Subject: Case File Review for SLIC Case RO0002896 and GeoTracker Global ID T06019794669, Red Star Yeast/1396 Fifth Street LLC, 1396 5th Street, Oakland, CA 94607

Alameda County Environmental Health (ACEH) staff has reviewed the Spills, Leaks, Investigations, and Cleanups (SLIC) case file for the above referenced site including the report entitled, "*Soil Excavation Report*," dated September 22, 2015 and received by ACEH on October 8, 2015 (Revised Excavation Report). The Revised Excavation Report, which was prepared on your behalf by Citadel Environmental Services, Inc, presents results from excavation of shallow soil containing elevated concentrations of metals, confirmation sampling, and soil disposal conducted in August 2011. In correspondence dated April 18, 2013 (attached), ACEH provided technical comments on a version of this report dated March 21, 2013. ACEH's April 18, 2013 correspondence identified several major and minor items that required additional information, clarification, or correction.

Subject: Case File Review for SLIC Case RO0002896 and GeoTracker Global ID T06019794669, Red Star Yeast/1396 Fifth Street LLC, 1396 5th Street, Oakland, CA 94607

FIGURE 4
AREAS OF EXCAVATION
COMMERCIAL PROPERTY
1396 5th Street
Oakland, California

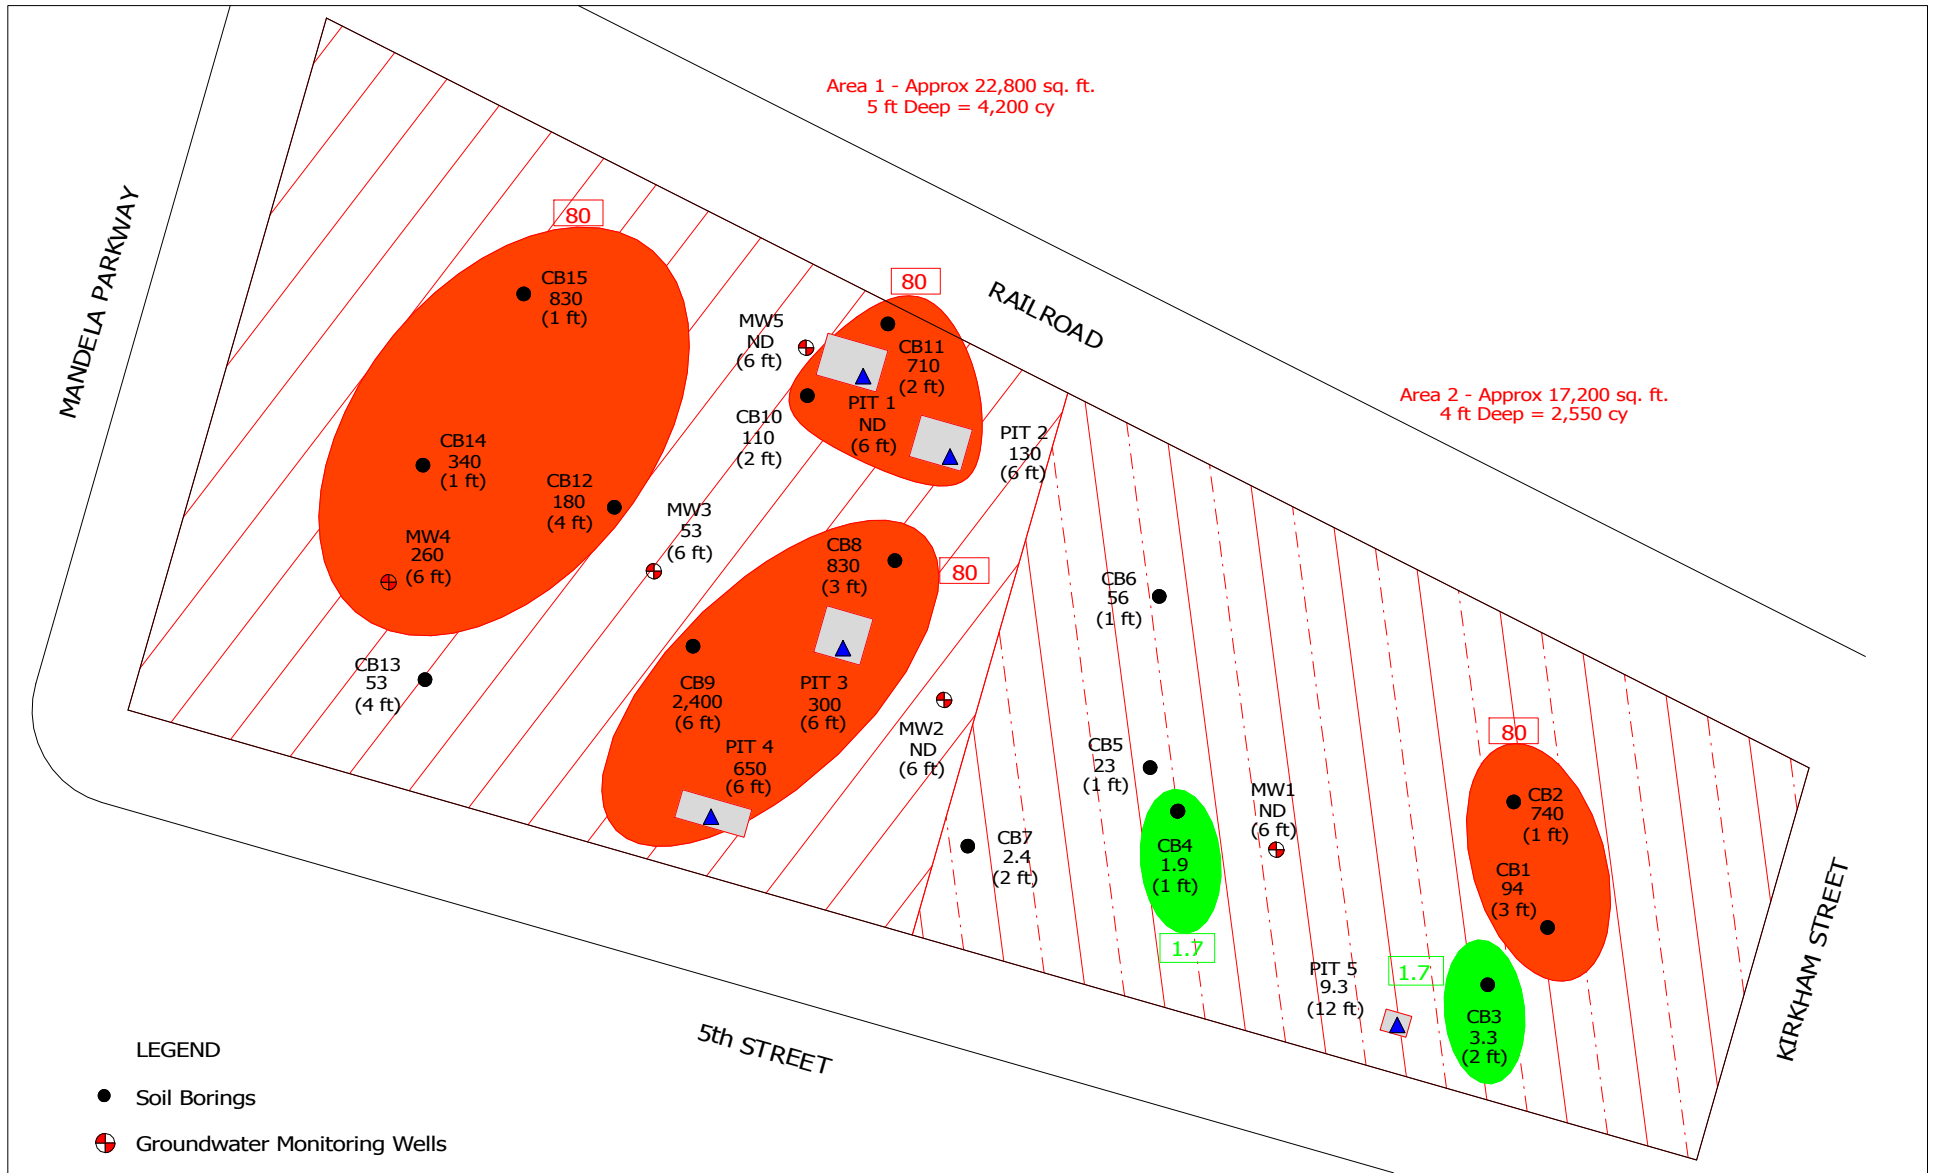
2. **Figure 4 - Confirmation Sampling Results.** Please revise Figure 4 to include the following:
 - Accurate boundaries for the excavation including depiction of sloped surfaces at the edge of the excavation.

- Clear indication on Figure 4 or a separate figure where fill material was left in place.
 - Sidewall sample locations in addition to bottom sample locations.

3. **Excavation on East Side of Site.** Figure 4 of the Revised Excavation Report shows the site being divided into three sections for the purpose of illustrating the extent of excavation. The “West Side Excavation” and “East Side Excavation” are generally consistent with the proposed removal of contaminated fill material. The easternmost section of the site labeled “Target Excavation of CB1-CB3” shows an outline that does not extend to the edges of the site. This extent is not consistent with the proposed extent of excavation shown on Figure 4 of the “Revised Remedial Action Plan” dated July 7, 2011 (attached) and Figure 4 shown in the previous report. This extent is also not consistent with the removal of contaminated fill material throughout the site. Six sidewall confirmation samples appear to have been collected from the Targeted Excavation on August 18, 2011. Lead concentrations in two of the six confirmation soil samples exceeded the screening level of 80 milligrams per kilogram. Please revise the report to include the following information or clarifications:

- Confirm whether fill material was left in place outside the boundary of the Targeted Excavation shown on Figure 4.
 - Prepare a separate figure that clearly shows the depth of excavation throughout the site including sloped surfaces.

- If fill material was left in place within the Targeted Area of Excavation, will any of the fill be exposed in landscaped areas of the development?
4. **Excavation on West Side of Site.** Figure 4 of the Revised Excavation Report shows an approximately 10 foot-wide area parallel to Mandela Parkway that appears to be outside the area of excavation. This area is not discussed in the report text. In the Revised Excavation Report requested below, please include the following:

- Please check the excavation boundary along Mandela Parkway and indicate whether the 10-foot wide strip represents fill at the surface or whether the excavation was sloped away from Mandela Parkway.
